# Product Change Notification

Product Change Notification: PCN-24-200133

DEUTSCH size 20 SF Socket Protective Sleeve New Capacity Tooling

**Traceability ID Location**

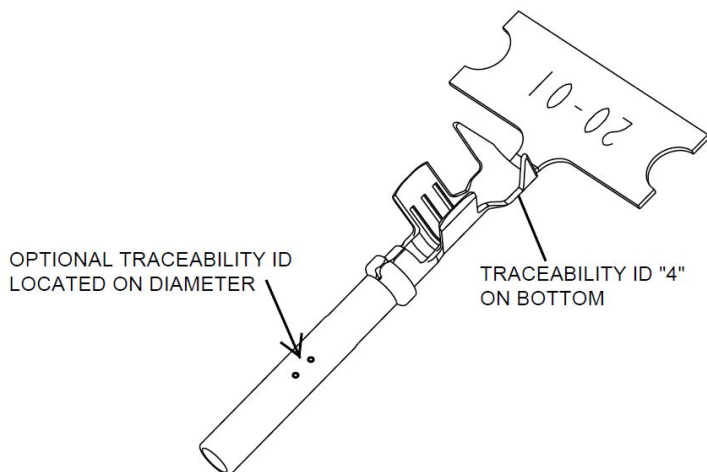
The Industrial and Commercial Transportation business unit of TE Connectivity is adding new capacity tooling for the protective sleeve for the part number(s) listed below which are manufactured at TE Suzhou China plant. These protective sleeves are used on DEUTSCH size 20 sockets that has a traceability ID 4 located on the bottom side of the insulation grip. Also, the sleeve will have optional two small dots on the diameter to signify they were made in China. See attached. These PNs are TE proprietary design, therefore considered catalog/general market product. PPAP and/or sample requests must be submitted within 14 days of PCN submission via ict-ppap-request@te.com or ePPAP system. Submission will not occur without request. If PPAP requested, disposition response is required within 14 days of submit date or it will be considered approved. Product drawing(s) are affected.
